ANN ARBOR HISTORIC DISTRICT COMMISSION

Staff Report

ADDRESS: 203 N State Street Application Number HDC24-0093

DISTRICT: Old Fourth Ward Historic District

South (New)

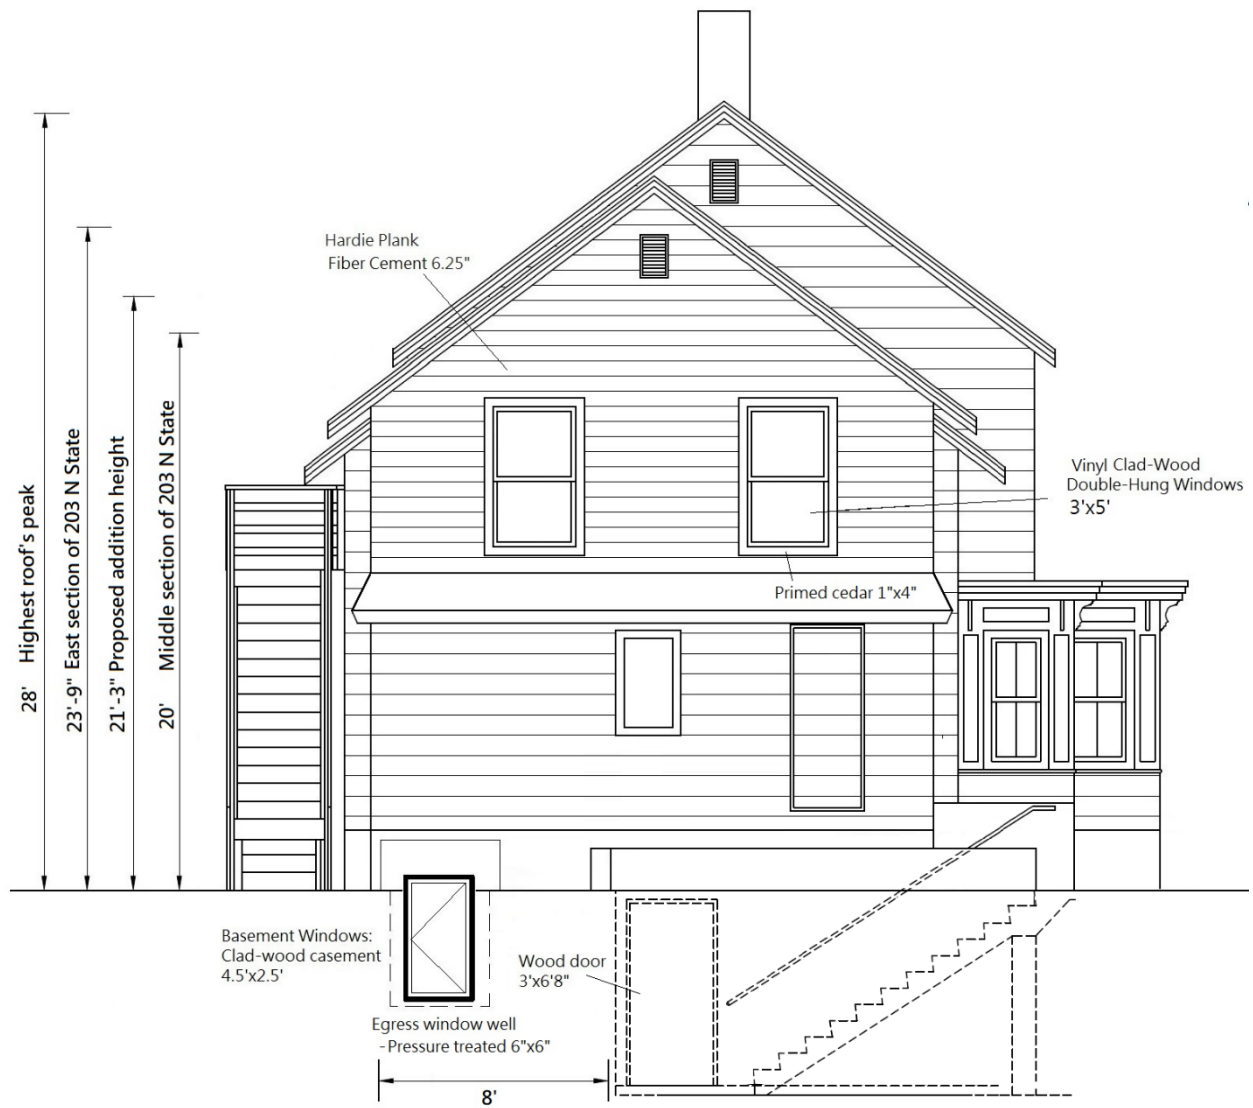
The front section of the house measures 28 ft. The middle section 20 ft. With the second-floor addition, the rear section measures 23 ft 9in. The applicant provided these measurements and calculated the height as the average of the roof's peak and eave line. Using these heights, the addition makes the rear section of the house 3 ft 9 in taller than the middle section but 4ft 3 in lower than the main two-story house block.

- Lift the rear part of the house to the height between the front (main) building and middle section of the house.
- The overhangs eave preserves the historical part of the building, uses different window and trim sizes, different cladding style to make clear what was historically.

Basement Floorplan

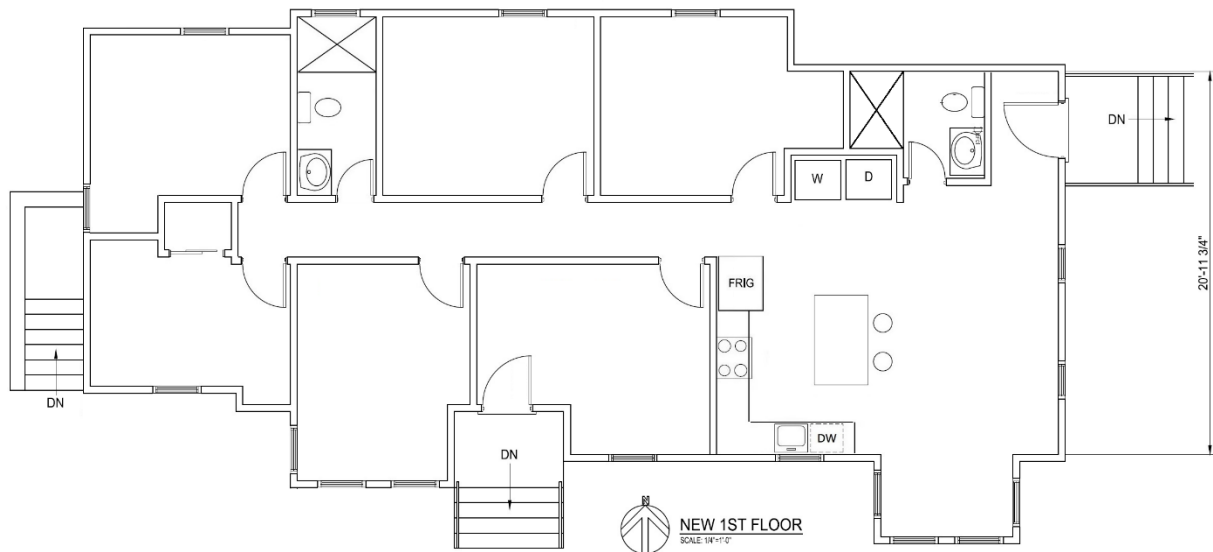
4. The basement entrance and stairs at the rear of the house is covered by a simple, non-historic structure. The applicant proposes moving the entrance door to the basement around 8 feet south, closer to Ann Street. This puts the entrance door below grade at the southwest, rear, corner of the building. The existing enclosure will be removed, and the drawings show a new concrete or masonry half wall and simple handrail around the new staircase. The current basement door is shown converted to an egress window. Staff believes it is not appropriate to build a new stair and door closer to the street when it could remain where it is (see the new basement floorplan drawing).

Staff does not recommend approval of the new basement entrance, stair and egress window on the west elevation and believes this work does not meet standards two or nine.
